# Site Accessibility Evaluation

**Tejon Park & Ride  
PU18-0085**

**1305 S Tejon St  
Colorado Springs, CO  
80905**

SUBJECT: Tejon St. Park & Ride Self-Evaluation

Image of narrow access aisles

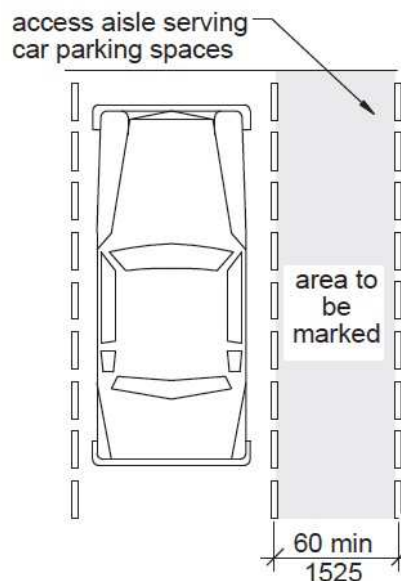
On the south side there are two access aisles approximately 4'-8" wide. On the north side the access aisles are 4'-9" and 6'-10" wide. However, the parking spaces range between 9'-0" and 9'-4" wide, wider than the 8'-0" minimum.

There are several access aisles narrower than 5'-0".

Restripe the parking spaces to 8'-0" wide with 5'-0" wide access aisles.

Image of accessible parking without signage

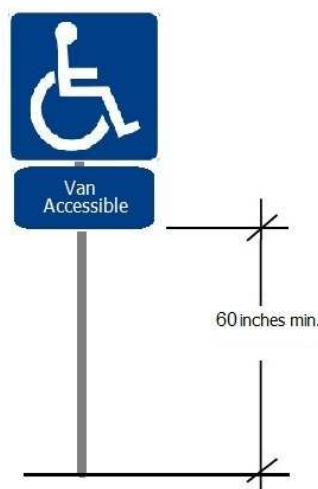
The required parking signage is missing.

None of the parking stalls have accessible parking signage.

Install signage. Flexible signs or some sort of barrier must be installed due to accessible parking location to the entrance/exit.

Image of lack of van accessible parking space

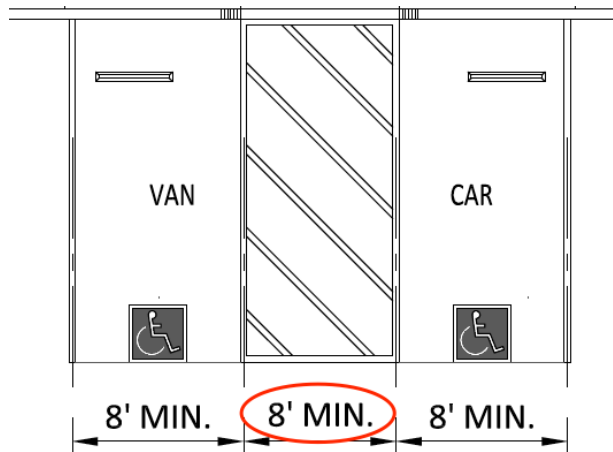
The access aisle is not a minimum 8 feet to the centerline of the stripe. There is a 9'-4" wide parking space with a 6'-10" access aisle. This space and access aisle together meet the 16'-0" required width, although they are not striped correctly as 8'-0" parking space with 8'-0" access aisle, or as 11'-0" parking space with 5'-0" wide access aisle.

There is not a van accessible parking space.

Restripe the parking and access aisle. In addition, add a van accessible parking sign.

Image of vertical displacement at curb ramp

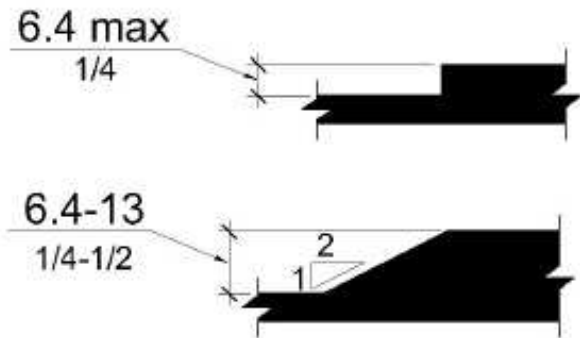
This ramp is on the west side of the southeast driveway into the park & ride lot.

There is 1/2" vertical displacement at the bottom of this curb ramp.

Grind to less than 1/2".

Image of vertical displacement at curb ramp

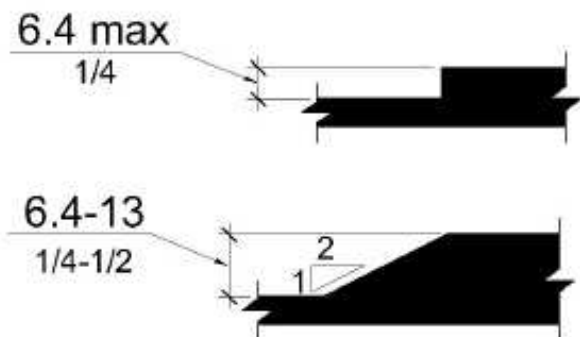
This curb ramp is at the east side of the southeast driveway into the park & ride lot.

There is 1/2" vertical displacement at the bottom of this curb ramp.

Grind to less than 1/2".

Image of vertical displacement at storm inlet

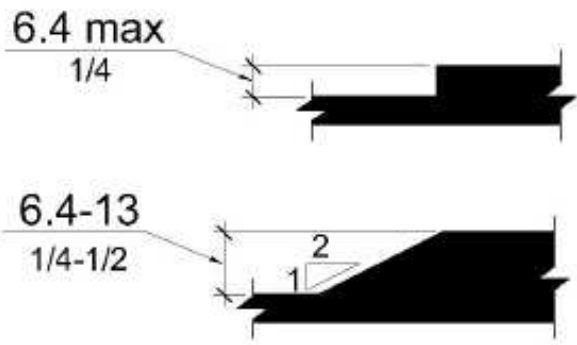
On one side of the storm drain there is 2" vertical displacement; on the other side is 1/2" vertical displacement.

There is vertical displacement at this storm drain on the access road between Nevada and Tejon.

Remove and replace the adjacent sidewalk.

Image of curb ramp without fall protection

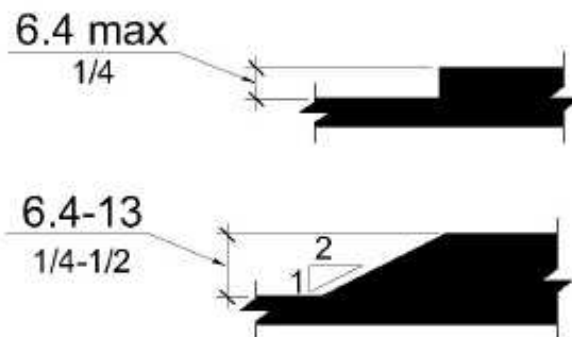
There is no fall protection at the end of the curb ramp.

There is a 6" drop at the edge of this curb ramp, which is accessible from the other side of the bridge pillar.

Install a guard to prevent pedestrians from tripping on the 6" curb.

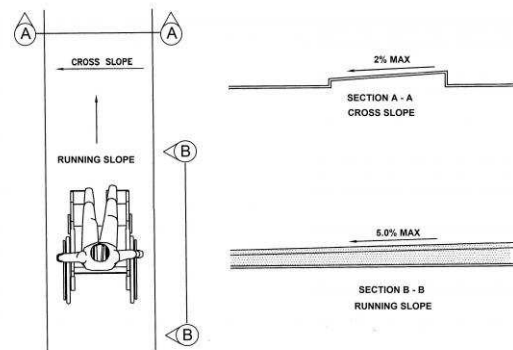
There is approximately 90' of sidewalk with cross slope between 3% and 6%. This is on the south side of the parking lot.

The cross slope of the sidewalk is excessive.

Remove and replace to provide maximum 2% cross slope.
